UNITED STATES PATENT AND TRADEMARK OFFICE

Office Action Summary

10/617,119

WEISS ET AL.

Fig.2

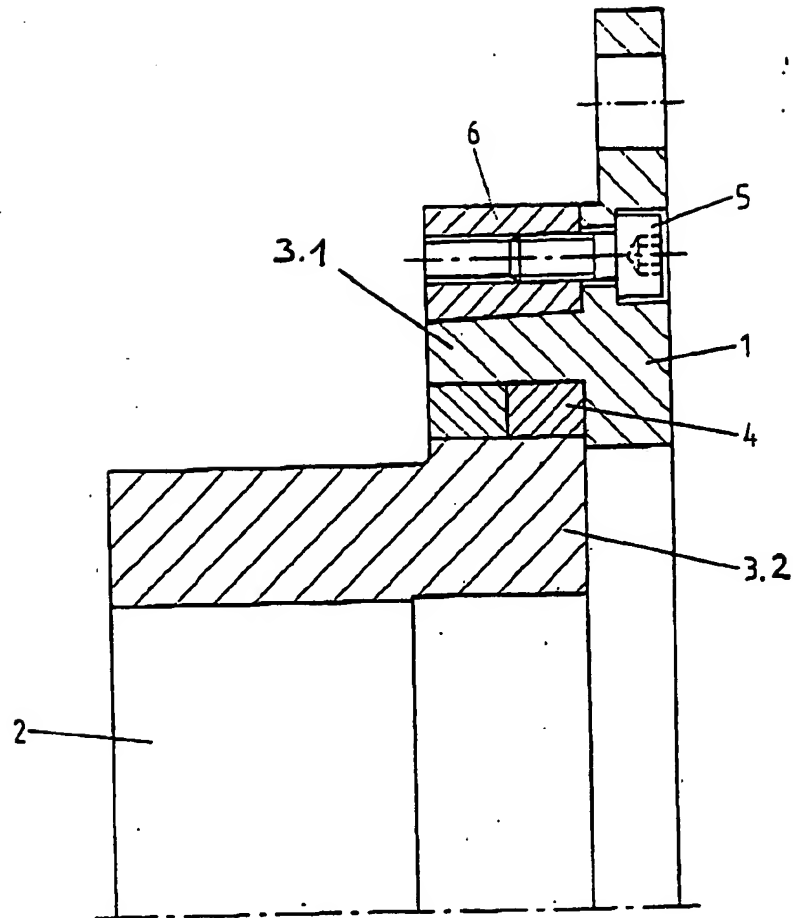
Acceptable
per
7/6/05
